Technical Memorandum

TO	Bruce Van Duyn	FROM	Cameron Swales and Eoghan O'Neill
	Carter Group Limited	DATE	7 November 2025
RE	Updated Road Reserve Operational Stormwater Management

Figure 1: Stormwater360 Filterra Bioscape Typical Layout and Details.

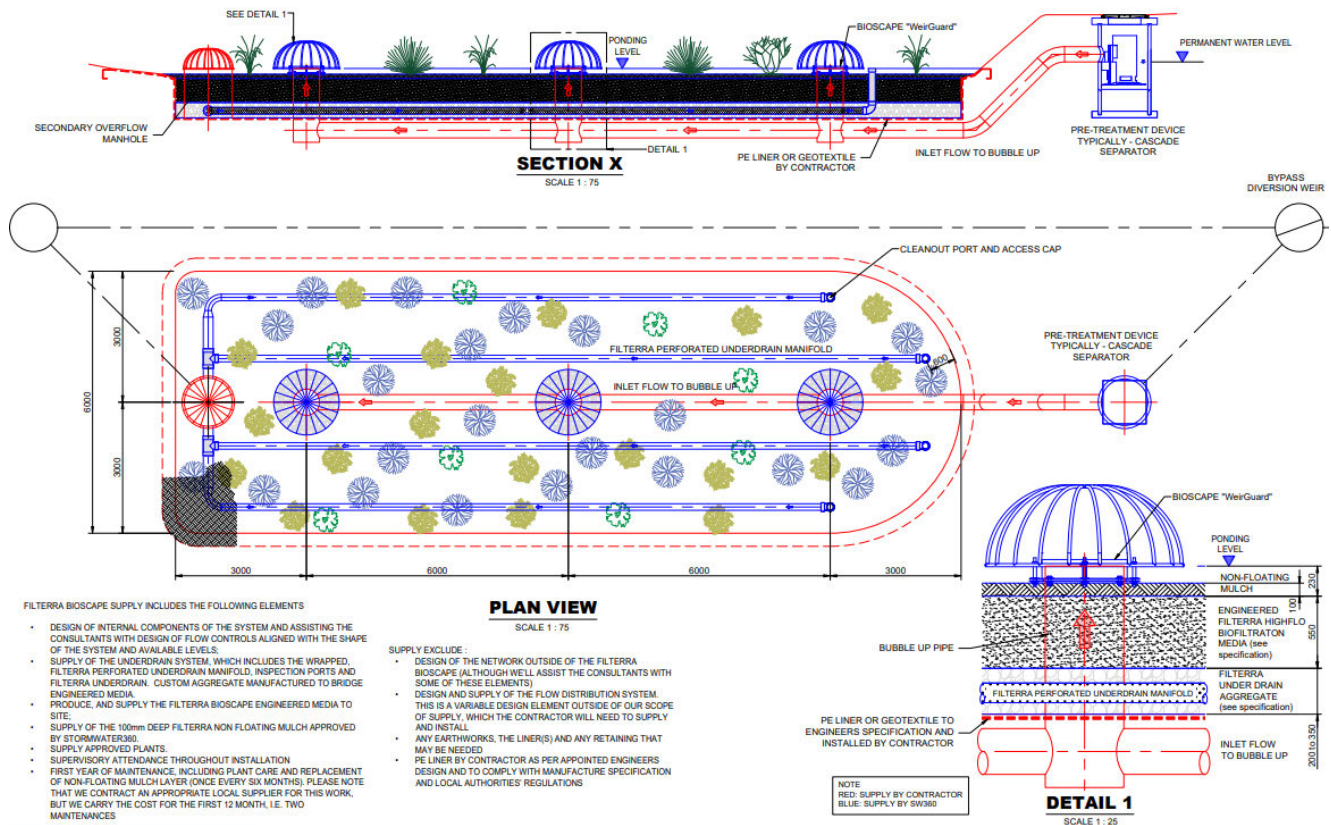
Following design review by Christchurch International Airport Limited (CIAL), and feedback received from Christchurch City Council (CCC), the proposed treatment and storage of runoff will be managed by a Stormwater360 Filterra Bioscape and Soak Pit system. This alternative approach will directly replace the Infiltration Basin and Soak Pit system outlined in previous reporting.

The proposed Stormwater360 Filterra Bioscape is an engineered bio-filtration system designed to treat runoff from large stormwater catchments. Given the high infiltration rate provided by the Filterra Bioscape, above ground storage is not required, and once treated, all road reserve run-off will be conveyed to an adjacent soak pit and discharge to ground via a soak pit up to the design 2% AEP design event. In addition to the Stormwater360 Filterra Bioscape, a control manhole with diversion weir will be required to spilt flow into the Filterra and allow excess overflow to convey directly to the soak pit.

Ponding within the Filterra Bioscape is anticipated to only occur during very high intensity rainfall events. These intensities would typically be associated with short duration "cloudburst" type events. During such an event, any ponding would dissipate very rapidly following subsidence of the high intensity rainfall i.e. within minutes. Any ponding that does occur within the bioscape is unlikely to be of a depth greater than 100 mm. The rapid dissipation of ponding is managed by the extremely high infiltration properties of the Filterra media. During typical rainfall intensity and/or medium to longer duration events, ponding within the Filterra is unlikely to occur.

Figure 2: Proposed catchment delineation (background layout plan courtesy of 'Capture Land Development Consultants')

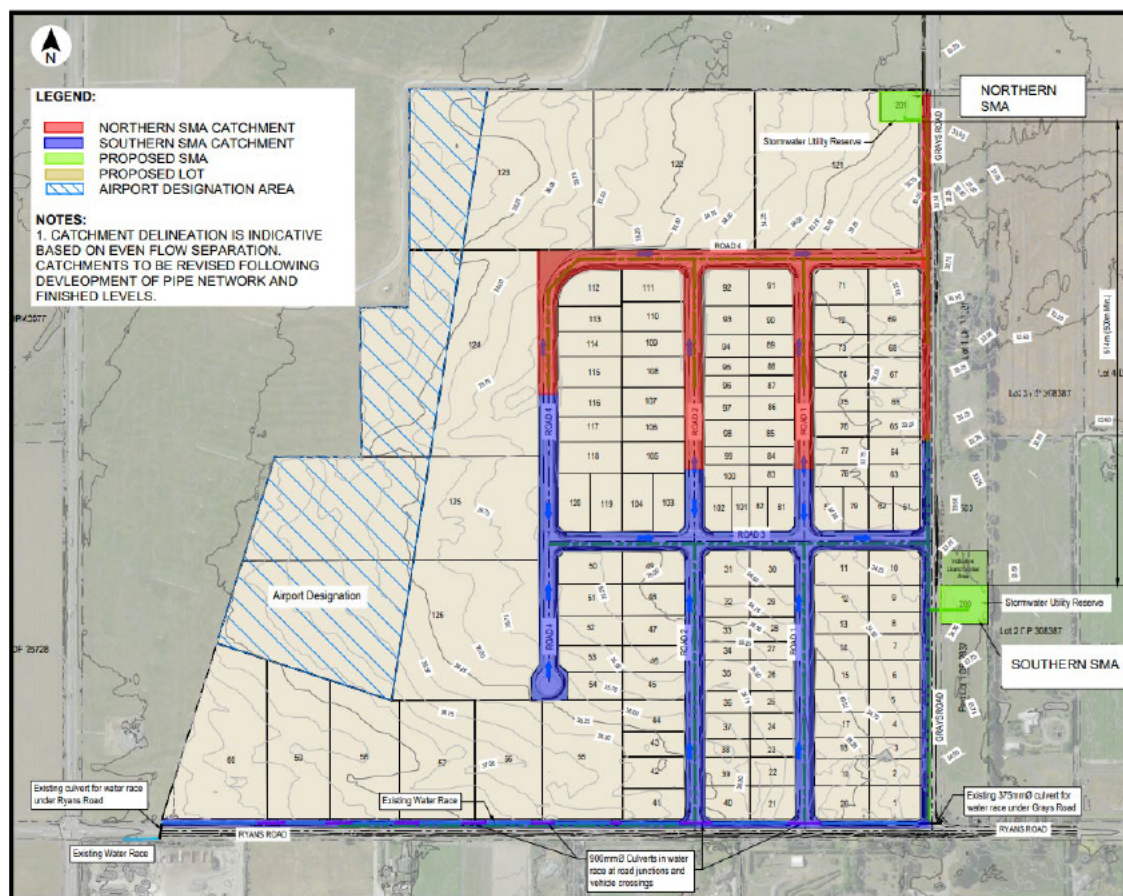
As discussed in the 'Stormwater Management Technical Assessment' previously completed by PDP, stormwater is to be collected from the road reserve via a network of kerb and channel, sumps and pipework which discharge to two SMA's Figure 2 below shows the proposed catchment areas for each SMA, with SMA's locations remaining unchanged to achieve minimum 500m separation. Each SMA will include a Stormwater360 Filterra Bioscape, primary overflow soak pit and additional 'capped' off overflow soak pit sized to treat and discharge all road reserve runoff up to the 2% AEP event.

Assuming the catchments as illustrated in Figure 2 above and design parameters outlined in Section 3.4 of the 'Stormwater Management Technical Assessment' previously prepared by PDP, estimated sizing of the proposed Stormwater360 Filterra Bioscapes along with sizes of proposed primary and contingent overflow soak pits have been developed to provide at least the minimum required system storage in accordance with the WWDG. PDP note that the provided bioscape sizing is subject to refinement at detailed design following, however any changes are expected to be minor.
